McIntosh

C 26

SERVICE INFORMATION

McIntosh SERVICE BULLETINLOW FREQUENCY FILTER SWITCH MODIFICATION

LEFT CHANNEL PREAMP PRINTED CIRCUIT BOARD 043-991

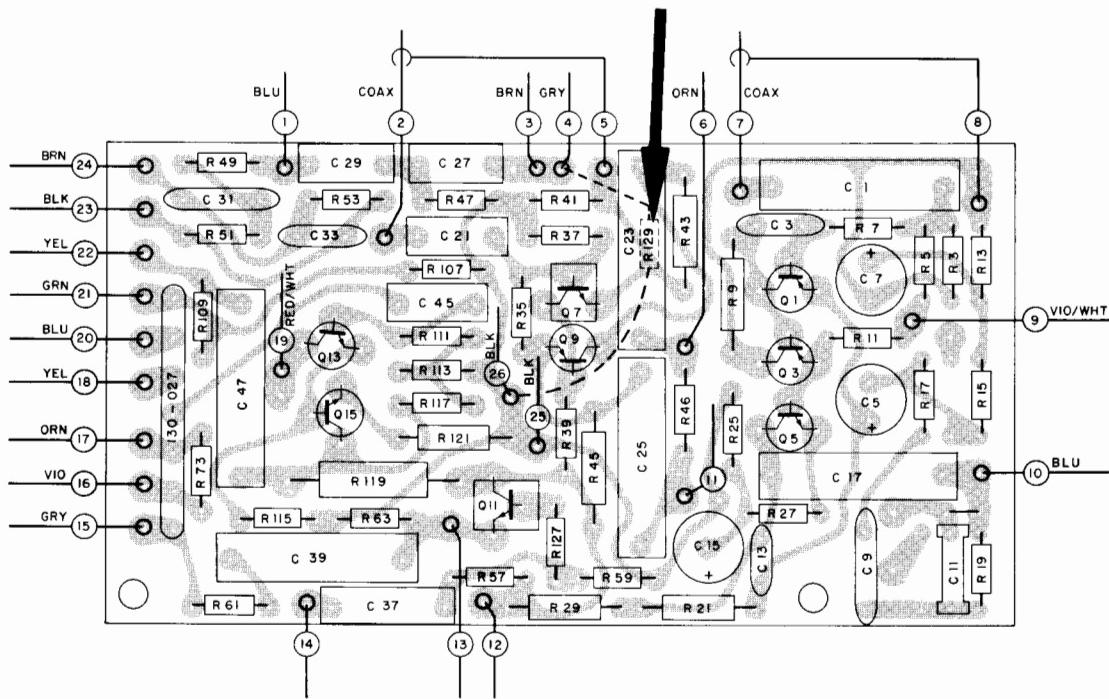
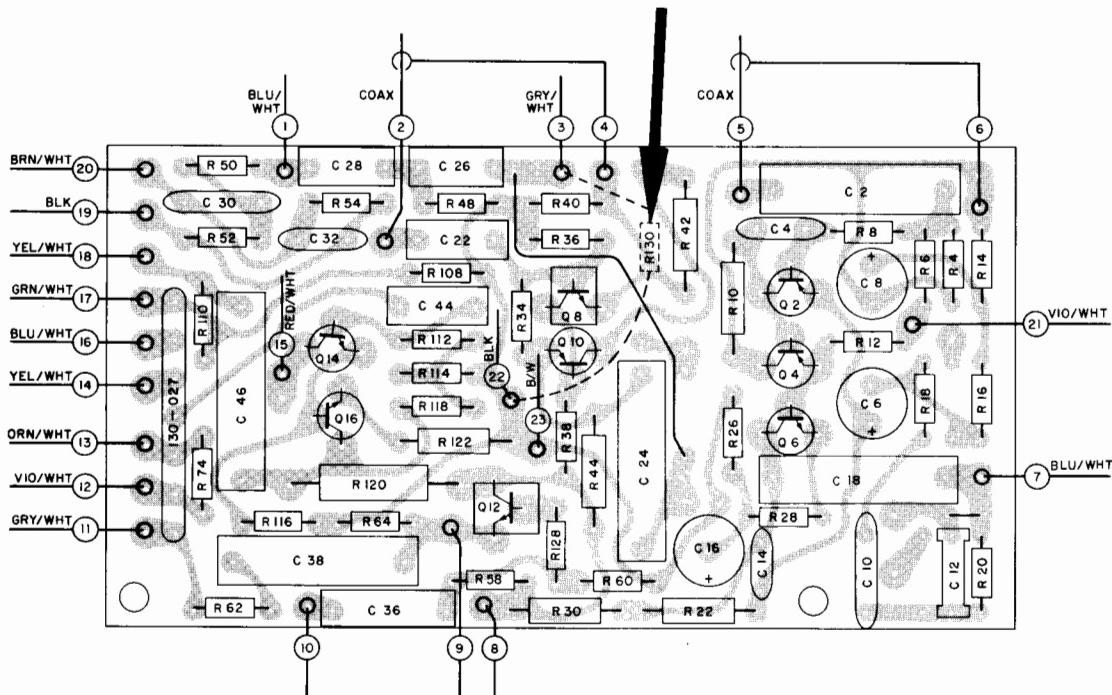
PURPOSE OF MODIFICATION: To eliminate a "popping" sound when the low frequency filter switch is depressed.

- Step 1 Remove bottom cover.
- Step 2 Add 1 resistor to the bottom side of each PC board as shown. The parts appear as R129 and R130 on the drawing.

Quantity	Part Number	Description
2	136-236	1 meg, 10%, 1/2W Resistor
